REVISION INFORMATION SHEET

ONTARIO PROVINCIAL STANDARDS FOR ROADS AND PUBLIC WORKS

VOLUME 4 MUNICIPAL AND PROVINCIAL COMMON DRAWINGS FOR ELECTRICAL WORK

MANUAL REVISION #34

OPSD 2453.070

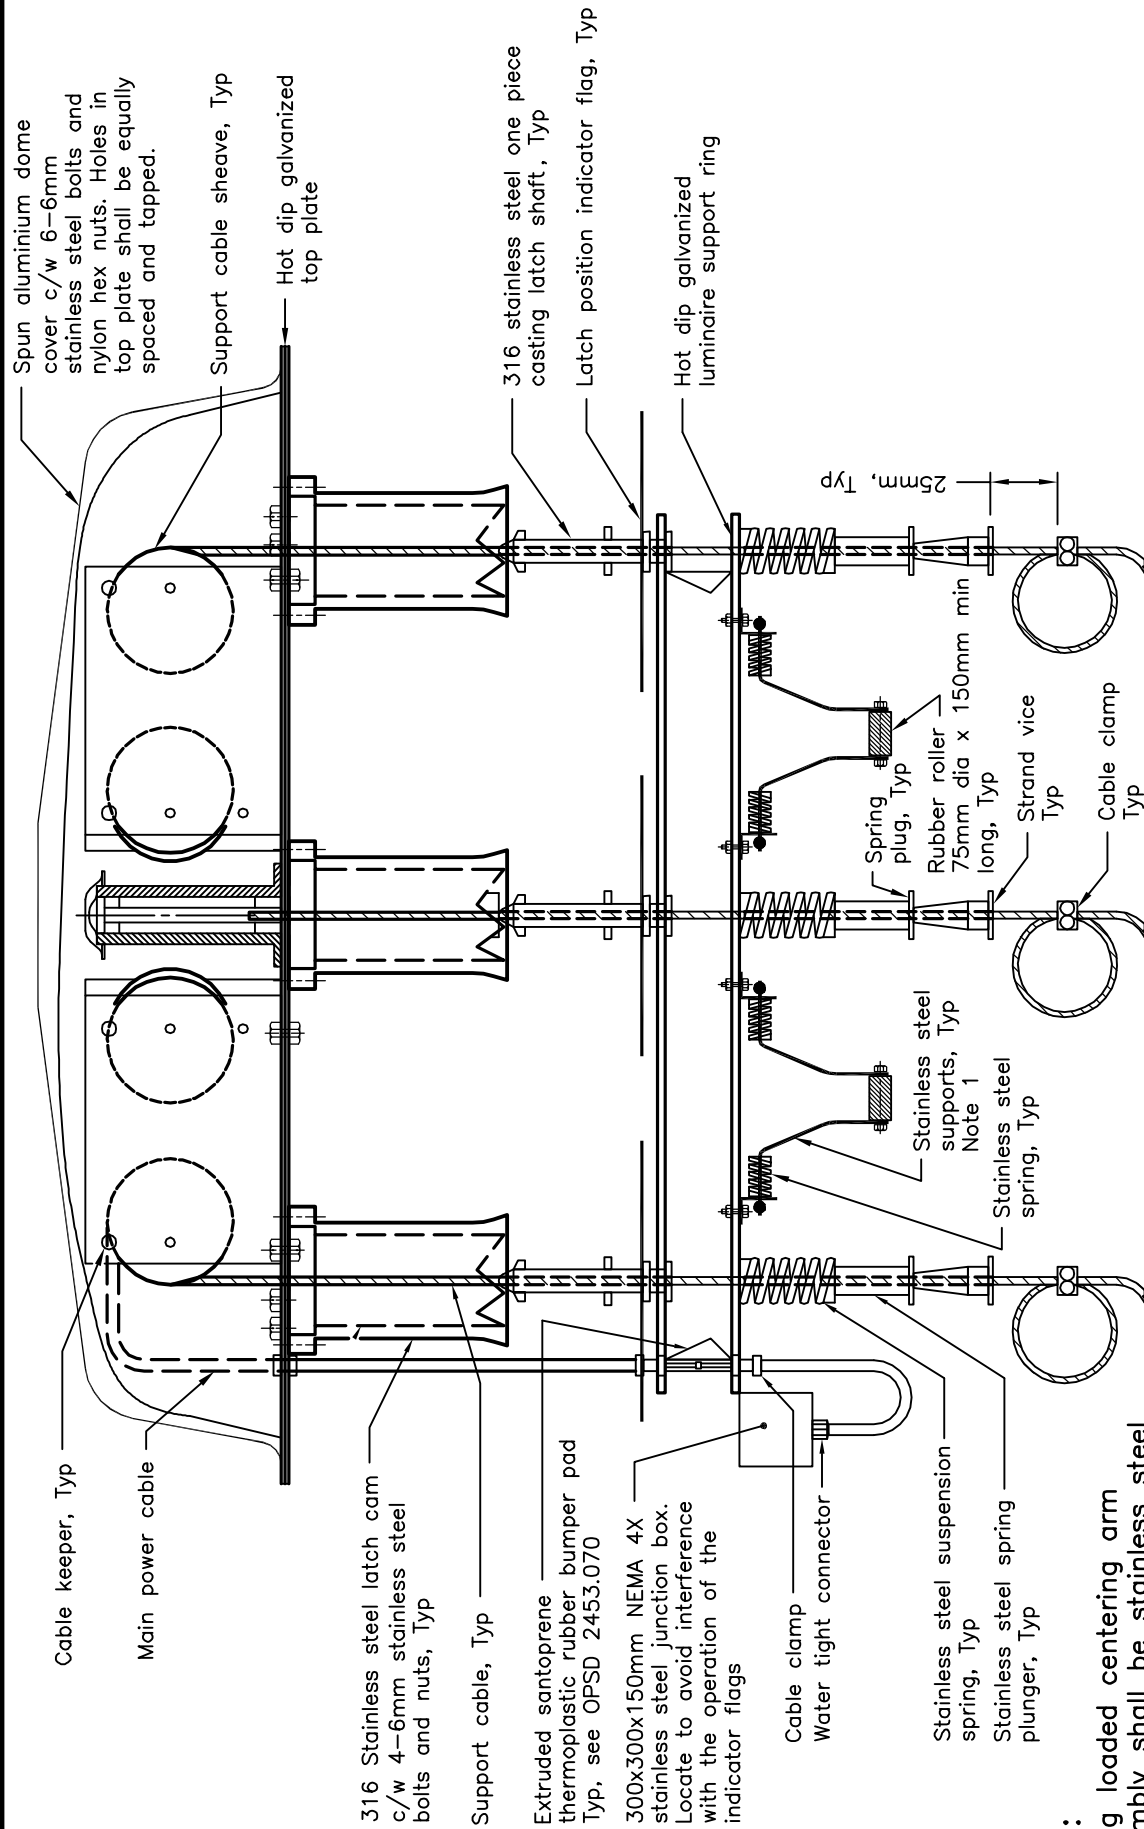
- Plan view; tenon arm length revised from 710mm max to 760mm max, junction box revised from EEMAC 4X to NEMA 4X stainless steel, and tenon mounting bracket thickness added.
- Section A-A view; installation of retaining screws and pop rivets reversed, width of tenon mounting bracket added, and locknut and double nut with plain washer labelled and dimensioned.
- Elevation view; hole diameter specified and bolt location dimensioned.
- New Notes A and B added. Other note reordered.

OPSD 2453.080

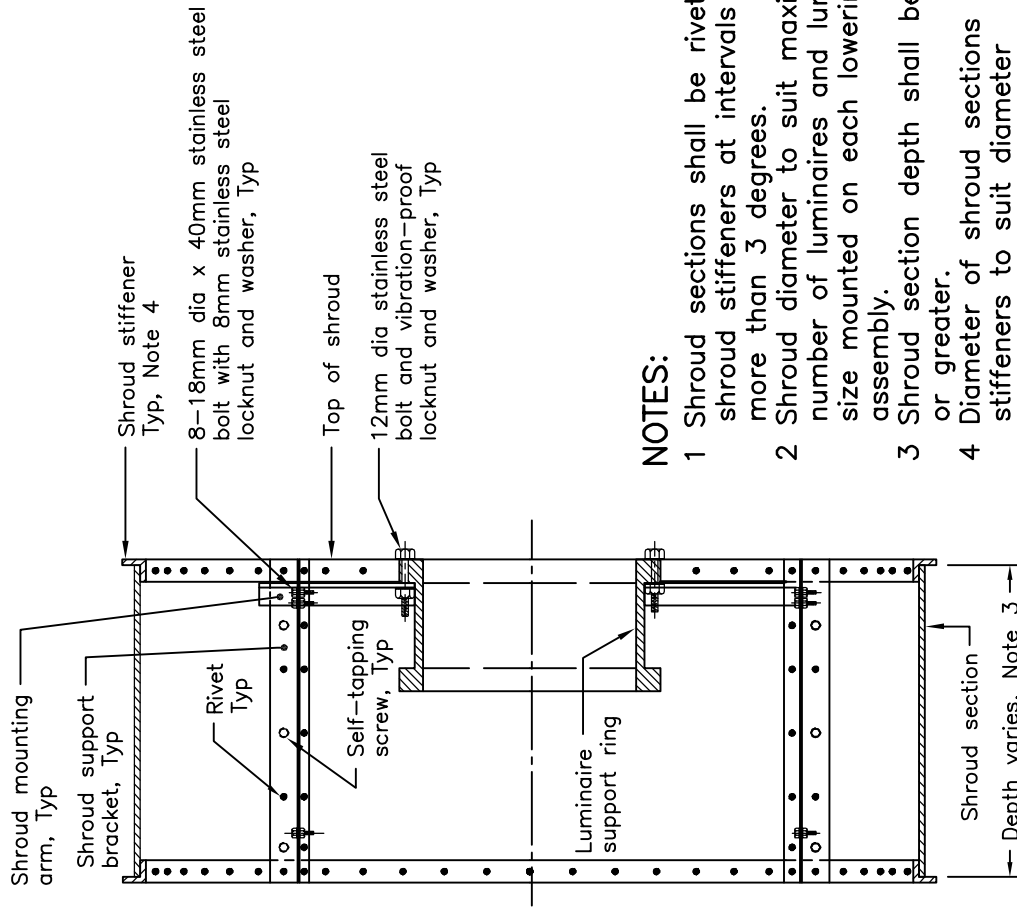
- Junction box revised from EEMAC 4X to NEMA 4X stainless steel.
- Allen head set screws, slip fitter, and galvanized gusset plate deleted.
- Rubber roller length revised from 150mm to 150mm min.

OPSD 2453.150

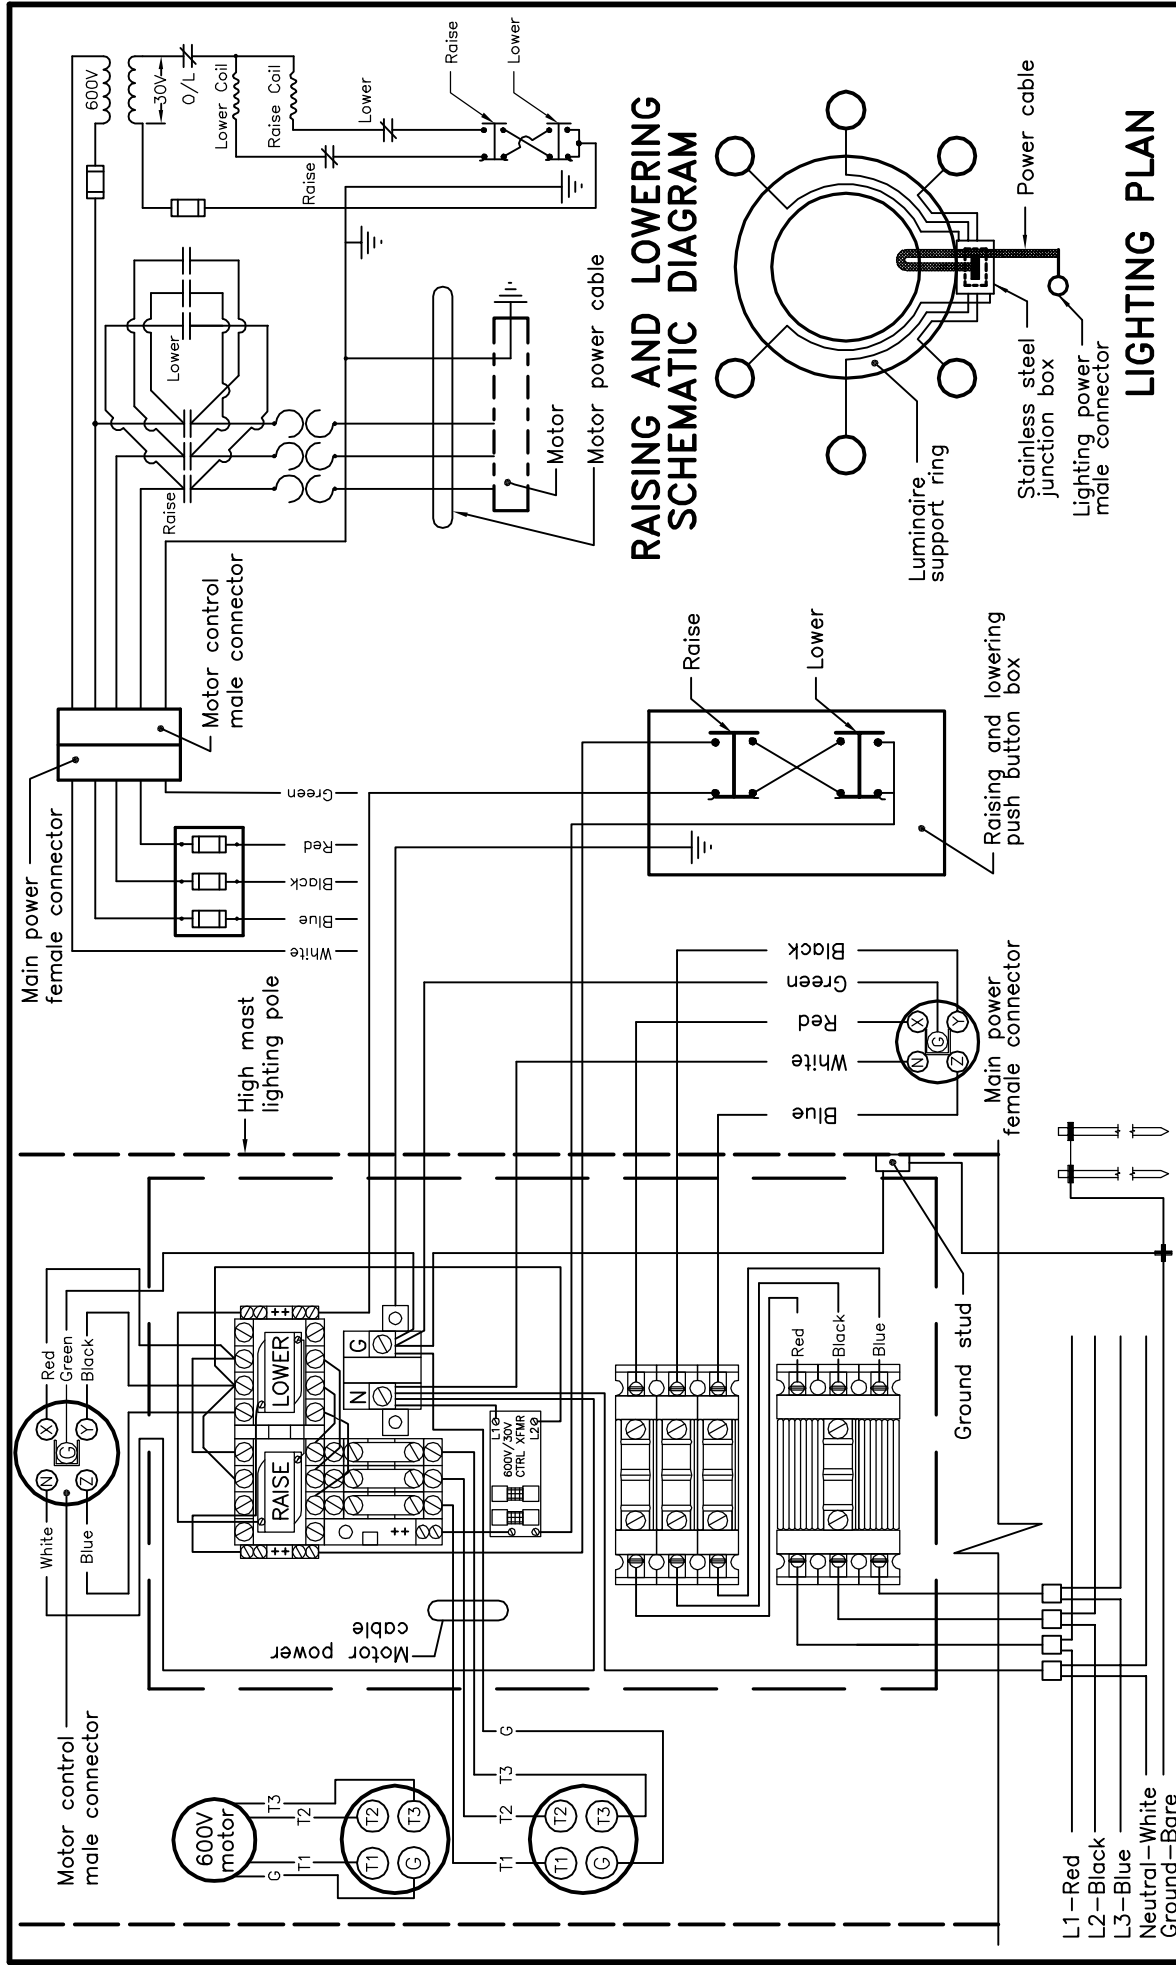
- PHASE A, PHASE B, and PHASE C revised to L1, L2, and L3; respectively.
- ID No. 15, additional strain relief connectors added.
- W revised to N for neutral.
- New Note 1 added.
- Note A, reference to OPSD 2453.160 deleted.

HIGH MAST LIGHTING POLE
INTERNAL DRIVE WIRING DIAGRAM
347/600V, 3-PHASE

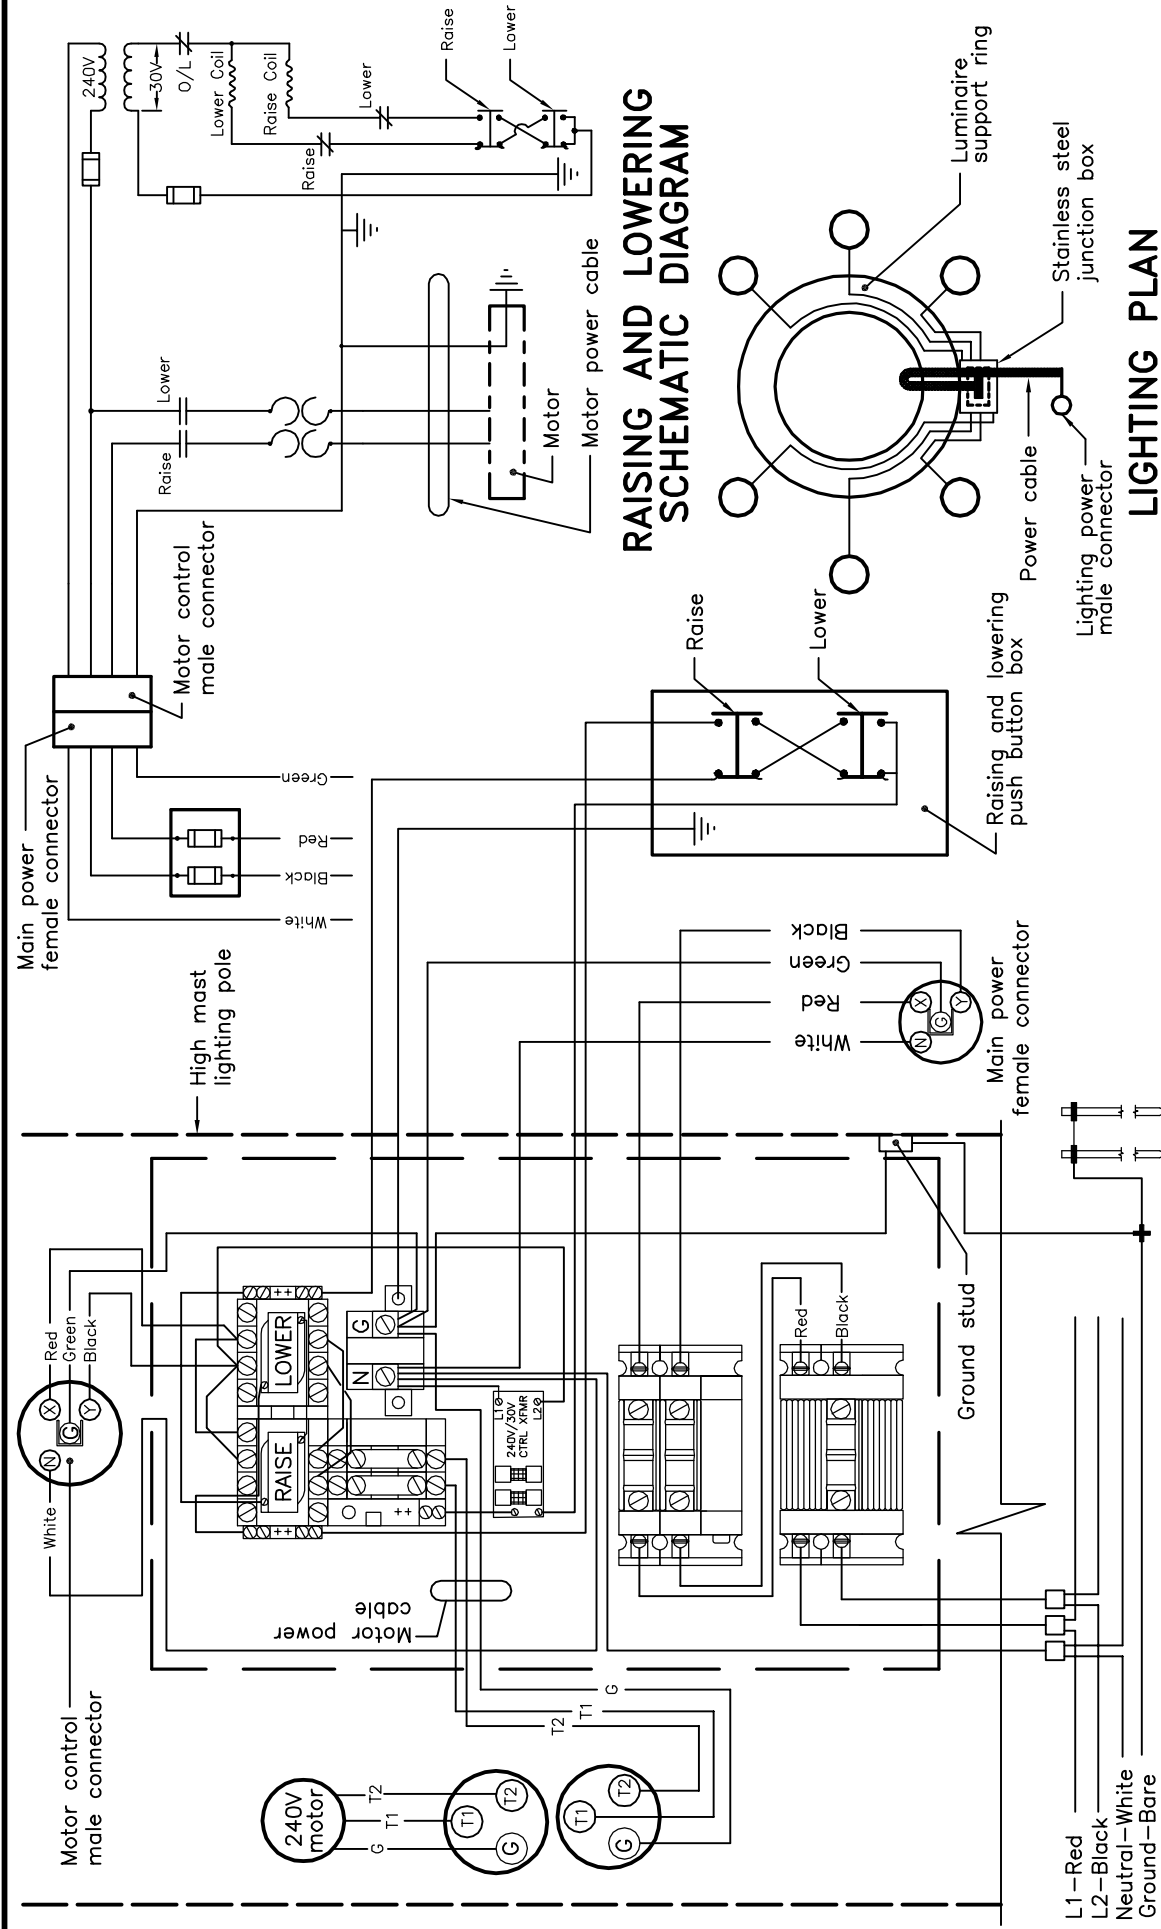
- Titles revised.
- W revised to N for neutral.
- Raising and lowering wiring revised.
- Raising and lowering push buttons and box labelled.
- Main power female connector and motor control male connector added.

OPSD 2453.190

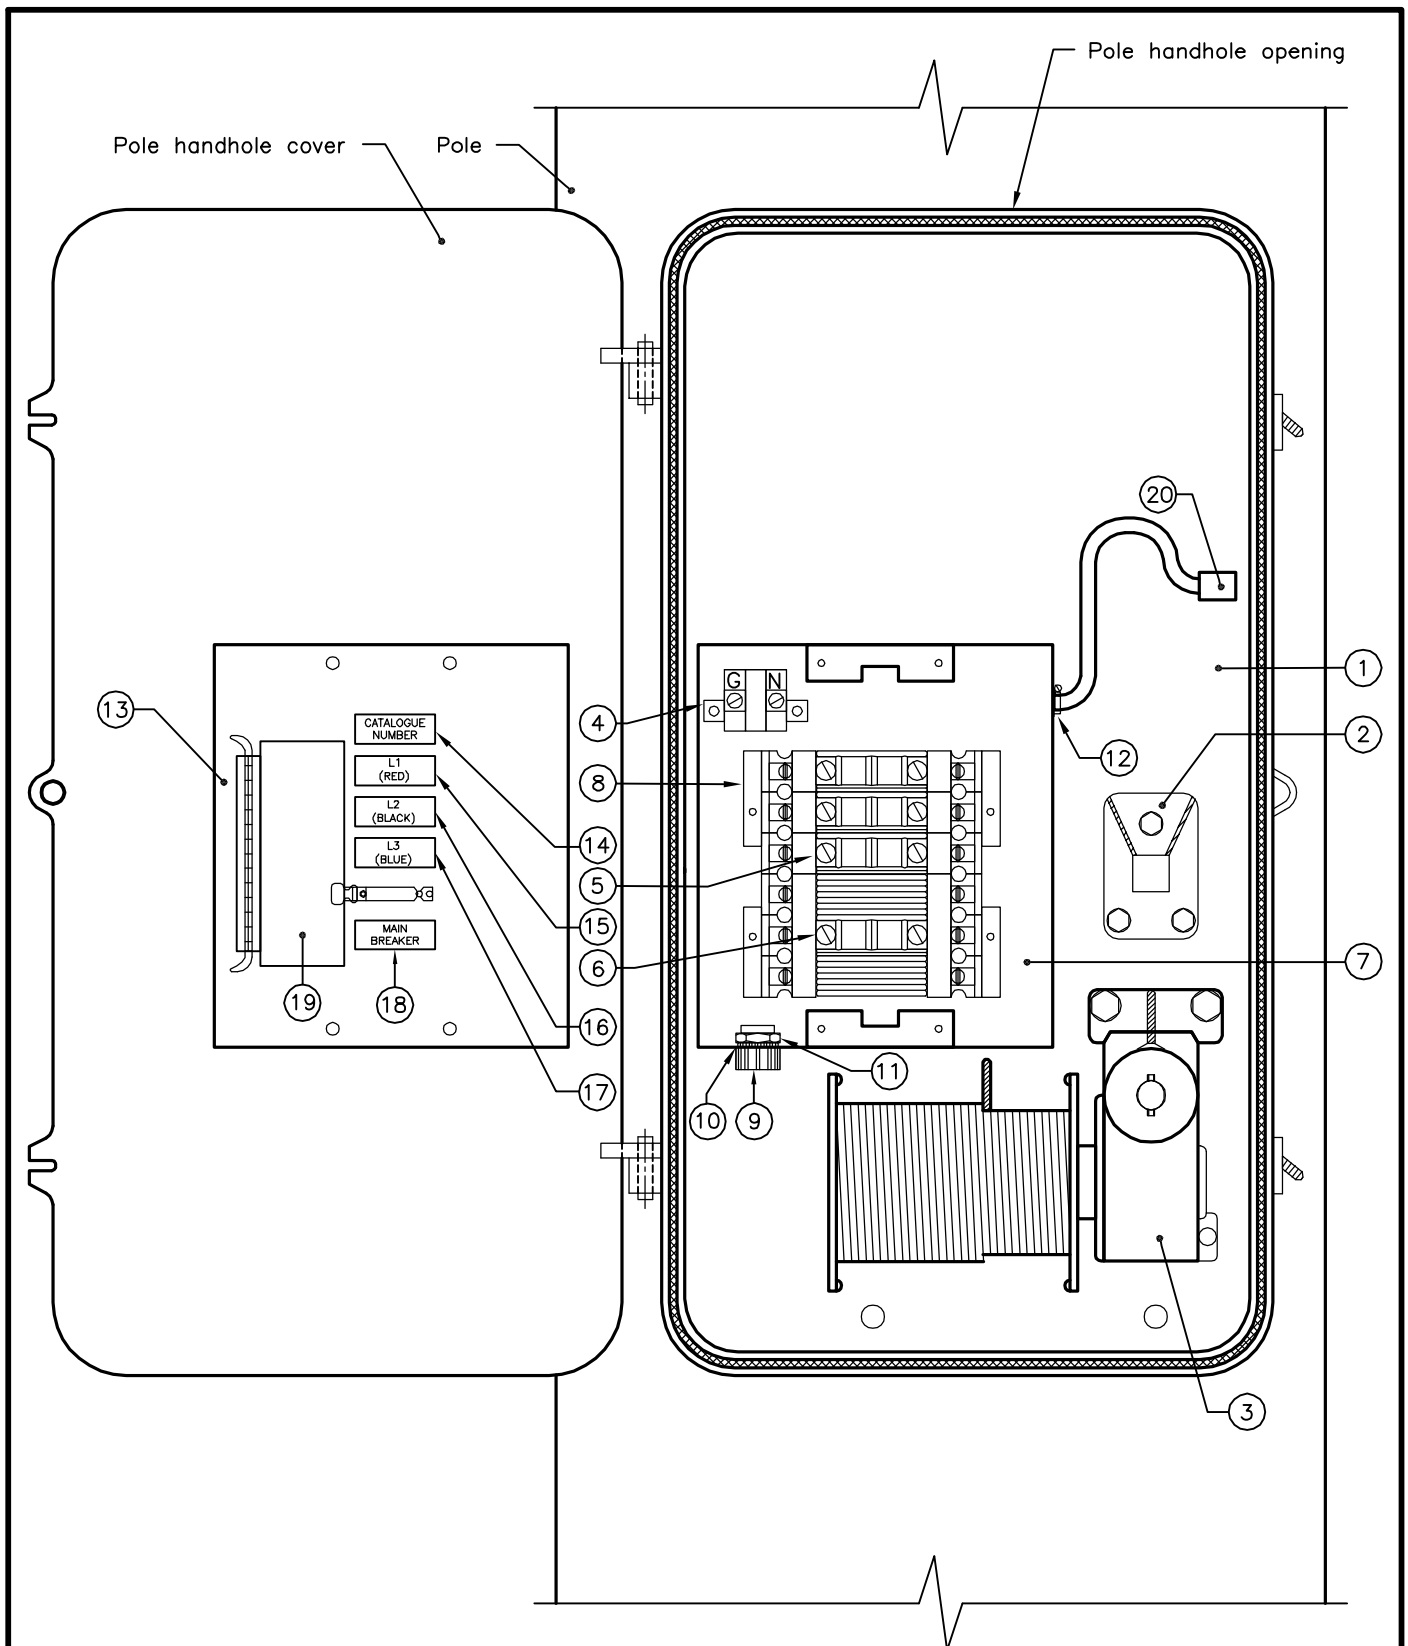
- Existing ID No. 4 deleted. Other numbers reordered.
- ID No. 3, 4, 15, 16, and 17; part descriptions revised.

ONTARIO PROVINCIAL STANDARD DRAWING	Nov 2016	Rev	1	
HIGH MAST LIGHTING POLE EXTERNAL DRIVE RAISING AND LOWERING EQUIPMENT-LAYOUT	----- -----			
	OPSD 2453.200

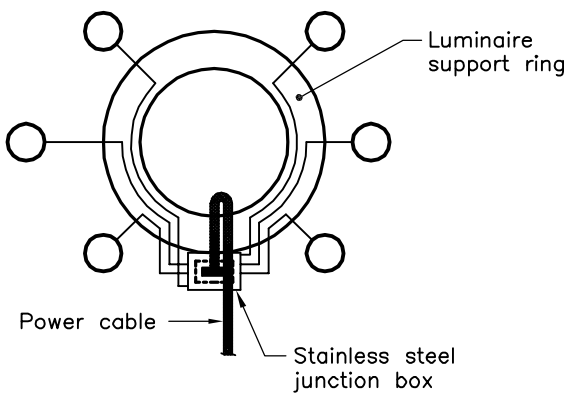
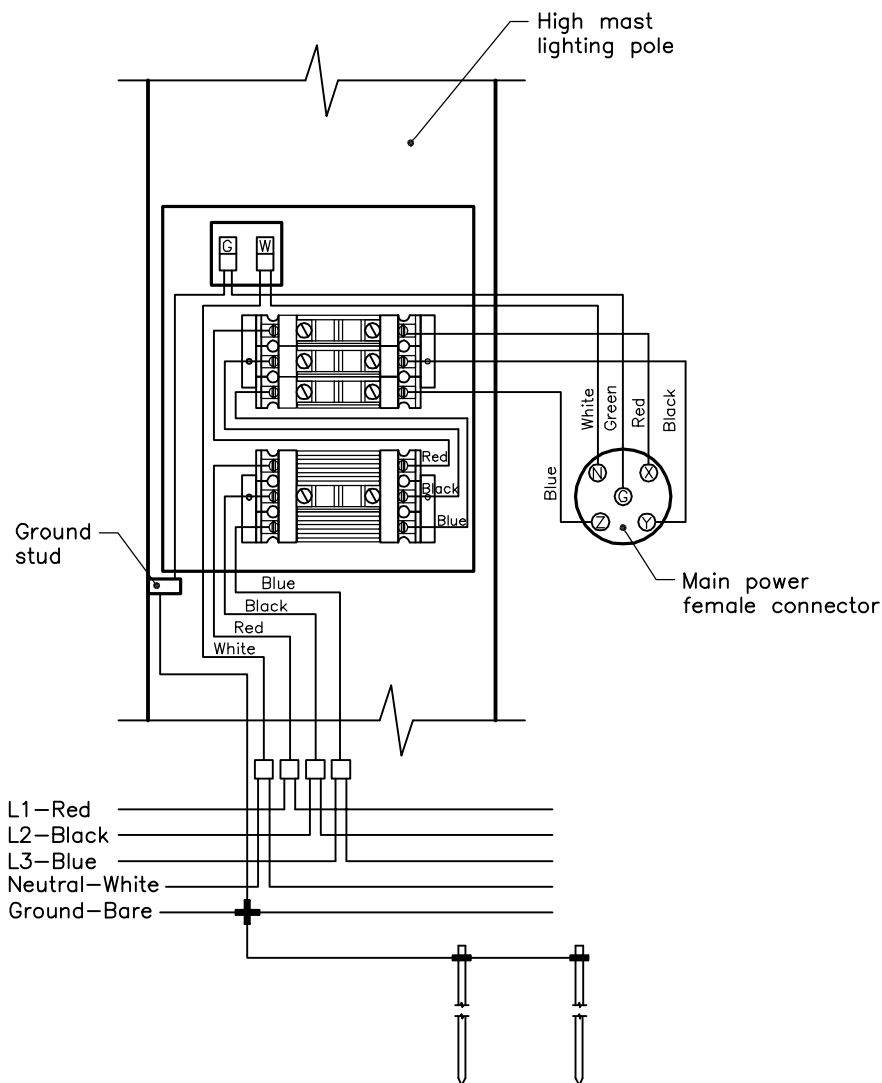
- ID Nos. revised to reflect renumbering in OPSD 2453.190.
- PHASE A, PHASE B, and PHASE C revised to L1, L2, and L3; respectively.
- W revised to N for neutral.
